(82nd GRSG, 29 April - 3 May 2002
agenda item 5.1.)

PROPOSAL FOR DRAFT AMENDMENTS TO REGULATION No. 43
(Safety glazing)

Transmitted by CLEPA

"Annex 2A

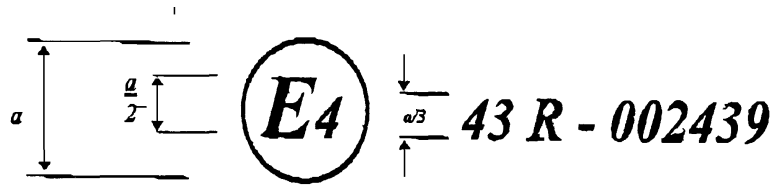
Rigid plastic glazings other than windscreens amend to read:

a = 8 mm min.

The above approval mark affixed to a rigid plastic glazing pane for forward facing

panels with a light scatter not exceeding 2 per cent after 1000 cycles on the outer surface and 4 per cent after 100 cycles on the inner surface shows that the component concerned has been approved in the Netherlands (E 4) pursuant to Regulation No. 43 under approval No. 002439.
